# Access Compliance Report

## Public Rights-of-Way

Intersection ID: 30269	Main Street: ARROLL_CT	Cross Street: FORTESCUE_DR	Location: NW
ADA ID: CC93A7A6DC70	Ramp Type: BlendTrans1	Initial Pass/Fail: Fail	Overall Compliance: No
		Severity Score: 25

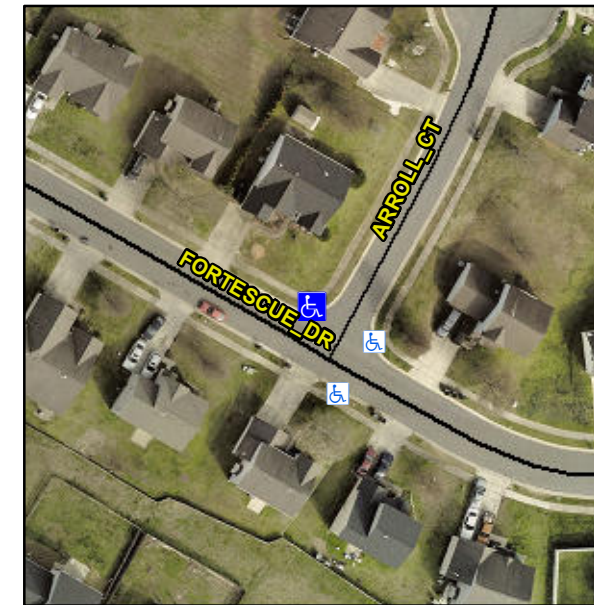
**Not Found, R304.5.3**

Compliance	Description	Data	Compliance	Description	Data
N/A	Ramp Length (in)	48.0	Yes	BlendTrans Slope (%)	3.6
Yes	Ramp Width (in)	48.0	No	BlendTrans XSlope (%)	11.0
N/A	Flare Type LT	N/A	N/A	Flare Type RT	N/A
N/A	Flare Slope LT (%)	N/A	N/A	Flare Slope RT (%)	N/A
N/A	Flare Traversable LT?	N/A	N/A	Flare Traversable RT?	N/A
N/A	Landing Length (in)	N/A	N/A	DWS Provided?	N/A
N/A	Landing Width (in)	N/A	N/A	DWS Contrast?	N/A
N/A	Landing Slope (%)	N/A	N/A	DWS Length (in)	N/A
N/A	Landing X Slope (%)	N/A	N/A	DWS Full Width?	N/A
N/A	Landing Curb? (Y/N)	N/A	N/A	DWS Offset (in)	N/A
N/A	Shared Landing?	N/A			
N/A	Gutter Ponding?	N/A	N/A	Gutter Slope (%)	N/A
N/A	Gutter Lip Ht (in)	0.5	N/A	Gutter X Slope (%)	N/A
N/A	Painted X Walk1?	No	N/A	Painted X Walk2?	No
	X Walk 1 Direction	To S		X Walk 2 Direction	To SE
	X Walk 1 Width (in)	N/A		X Walk 2 Width (in)	N/A
	X Walk 1 Slope (%)	4.6		X Walk 2 Slope (%)	4.5
	X Walk 1 X Slope (%)	7.1		X Walk 2 X Slope (%)	6.4

N/A	Ramp inside XWalk1?	N/A	N/A	Ramp inside XWalk2?	N/A
	Road Slope (%)	9.4		Clear Space?	N/A
	Road X Slope (%)	3.2	N/A	Clear Space to XWalk (in)	N/A
N/A	Any Obstructions?	N/A	N/A	Storm Grate/Utility Hazard?	N/A
	Obstruction Type			Storm Grate/Utility Type	
		N/A			N/A
		Yes		Surface Condition? (G/P)	Good
		No		Curb Slope (%)	16.1

**Remove & Replace Curb Ramp With Two New Directional Ramps or Equivalent.**
